AIRWORTHINESS DIRECTIVE

№ 2018-322-01

Applicability - RRJ-95 Aircraft

TECHNICAL DECISION RRJ0000-OR-470-1975

Fig.1. Passenger Cabin Window.

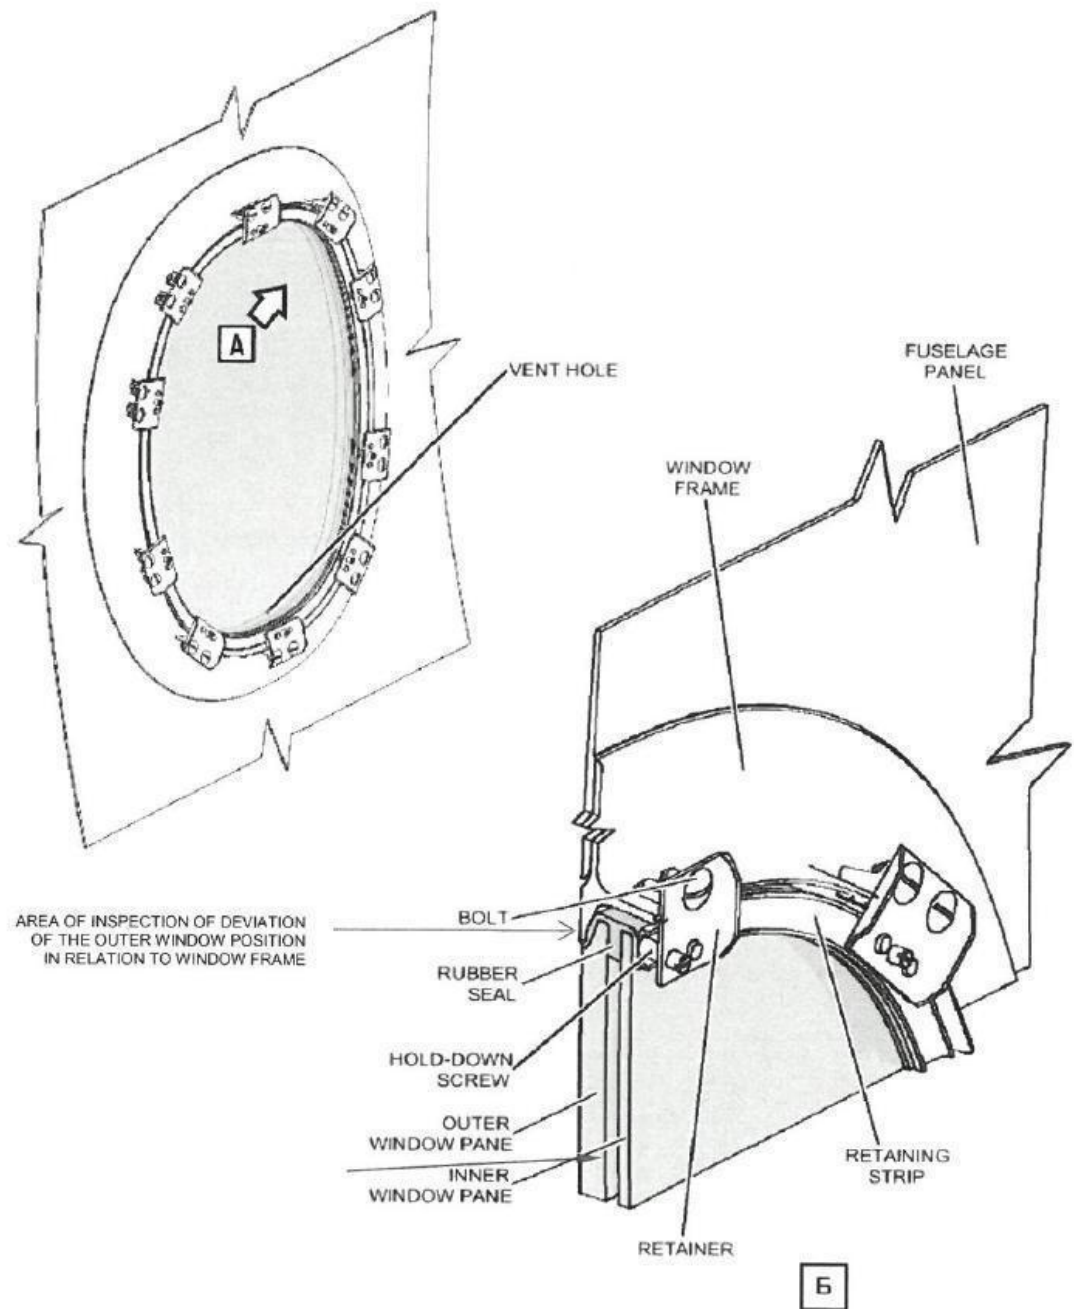
NOTE 3: Installation of retainers p/n T7.92.0704.105.000.70/B with the bolts p/n 5-12-Ц-ОСТ 1 31158-80 to be performed with application of a thin layer of paste LU-052 or sealer IS-069 on a threaded part of screws after preliminary cleaning of the contacting surface of the retainer and retaining strip (see Fig.1) with a cleaning rug soaked in solvent.

NOTE 2: During retainers installation instead of previously installed hold-down screws p/n 5-16-Хим.Пас-ОСТ 1 31574-80 to perform installation of new screws with hexagon head p/n 5-16-Хим.Пас-ОСТ 1 31503-80.

To perform tightening of screws IAW AMM 56-21-01-900-801. To perform tightening of screws 6 (clause 4 "Б (6)", page 402) as per the following procedure: removing one-by-one each screw on the opposite sides of the strip until the gap appearance, again tighten the screws until they contact with the retaining strip. After contact to turn the screw for 1.5 of the turn, at that deformation (bending) of the corner for 1.5 mm is allowed.
